Public Input No. 292-NFPA 99-2021 [New Section after 3.3]

3.3.14 Auxiliary Connection

Boom Mount to structure diagram:

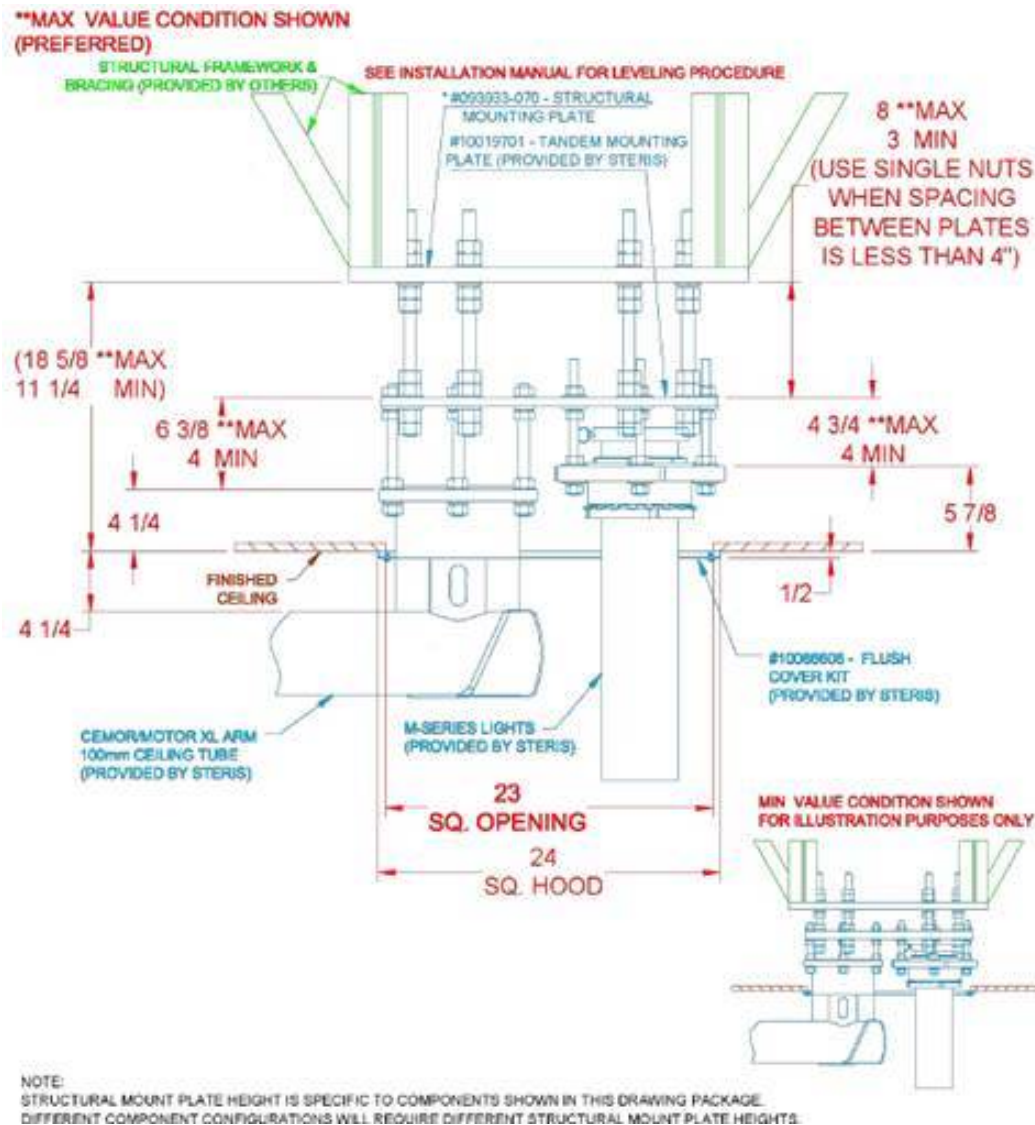
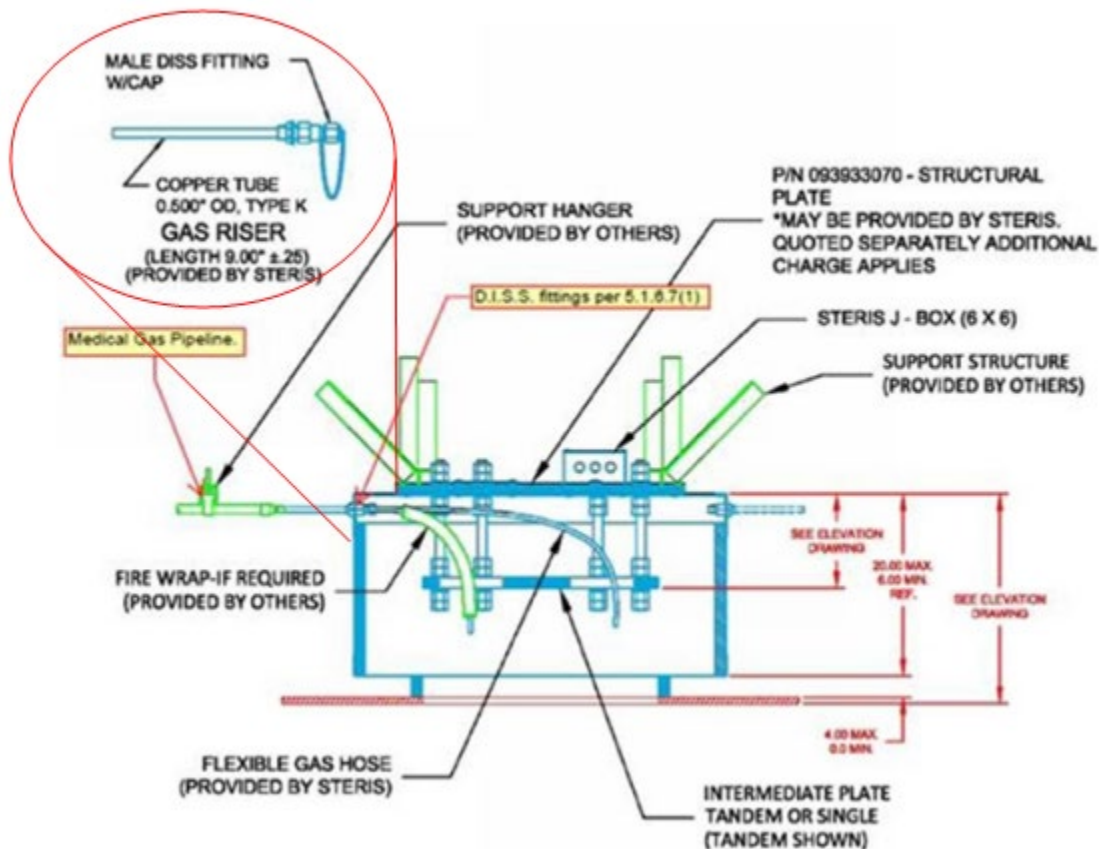
Manufactured assemblies are manufactured offsite and tested to meet a specific standard and the connected to the fixed piping on site. Many of these manufactured assemblies include flexible hoses and of these assemblies, some are fixed (do not move once installed) and others are articulating (surgical booms, ICU booms, etc.).

The screenshots below show how the boom mounts and how the medical gas hoses enter the boom.

Note : there is no access panel of the manufactured assembly. Once the ceiling access panel is opened, the fittings are accessible (without having to remove another access panel)

I have spoken to Medical Gas installers and this installation is typical. In fact, as noted in the sketch above, the manufacturer provides the copper “pigtailes” that are intended to be connected to the fixed piping at the location noted (above the ceiling). It is standard practice to provide access panels to provide access to both the medical gas connections and the electrical junction boxes. 99 -5.1.14.2.3.1.

Figure A.5.1.3.10(a) Distance Between Bulk Oxygen Systems and Exposures.

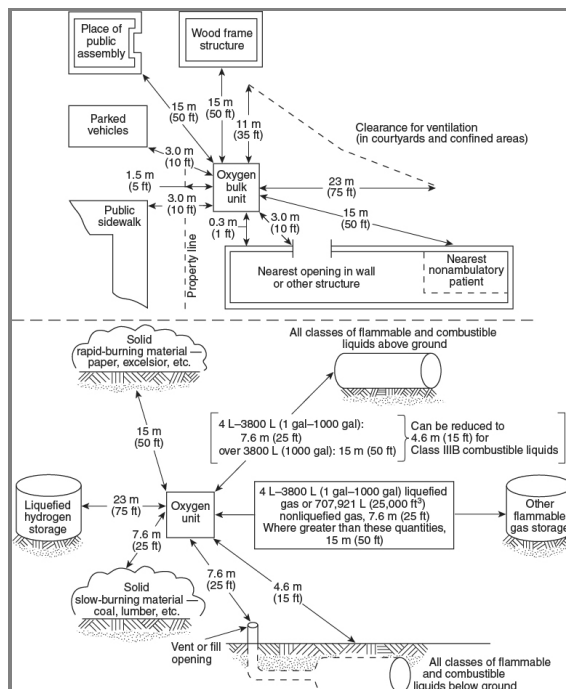
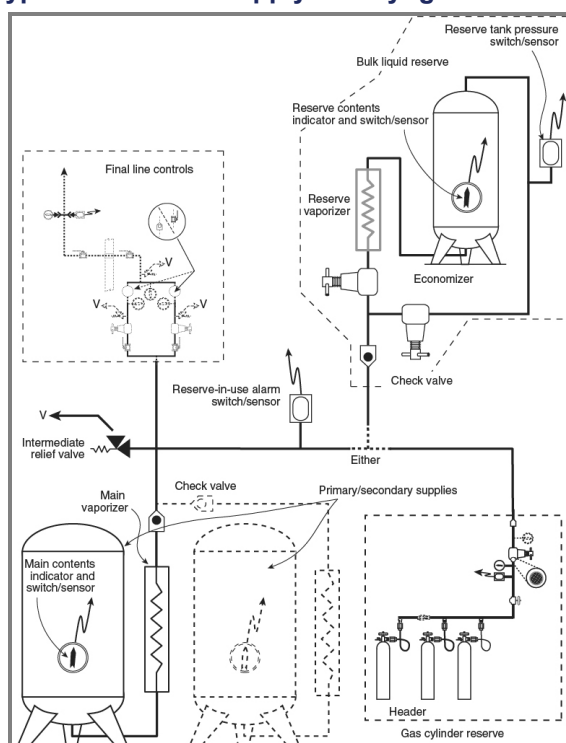
For bulk oxygen systems, see NFPA 55. Two possible choices of reserves are illustrated in Figure A.5.1.3.10(a) and Figure A.5.1.3.10(b). Both are not required.

Figure (a) does not show reserve supplies. Figure (b) shows both the liquid option and the cylinder option.

Statement: The current text incorrectly identifies Figure A.5.1.3.10(a) as bulk oxygen reserve option diagram; it is a diagram of the separation distances for bulk oxygen systems. This Annex comes from the section in NFPA 99 that is extracted from NFPA 55. To keep with the extracted information, the current NFPA 55 Figure is included.

Figure A.15.3.3.5(a) Typical Wet or Dry Piping System with Single Vacuum Pump Source.

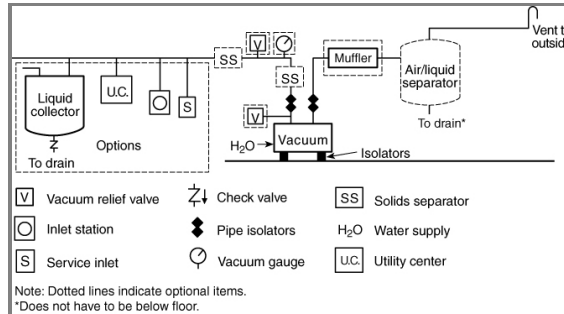
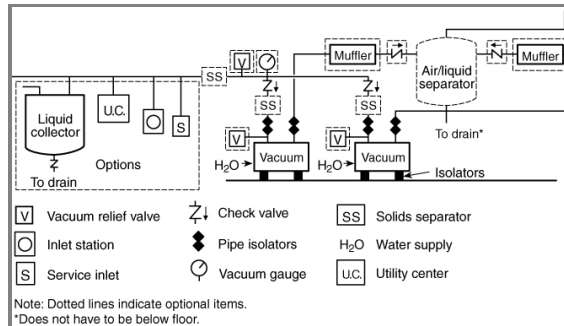
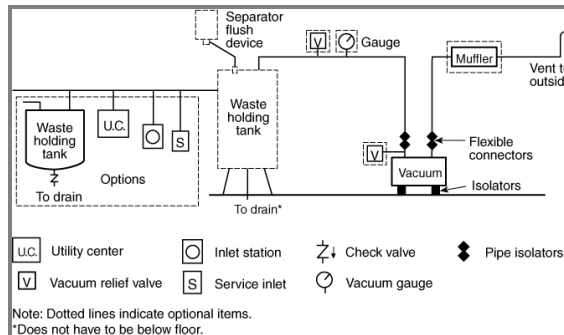
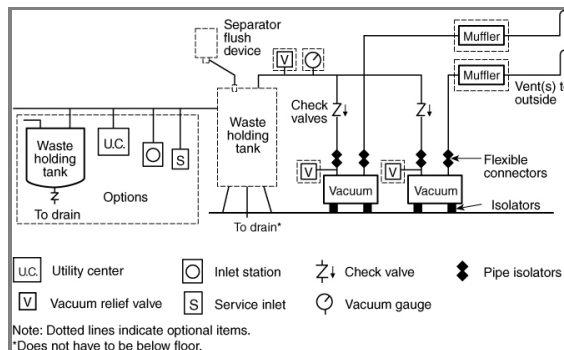
The dental vacuum exhaust proposal will allow new technology that needs to be reflected in the drawings.

Statement: The revision modifies Figures A.15.3.3.5(a) through (d) by including exhaust filters to more accurately represent typical dental vacuum arrangements.
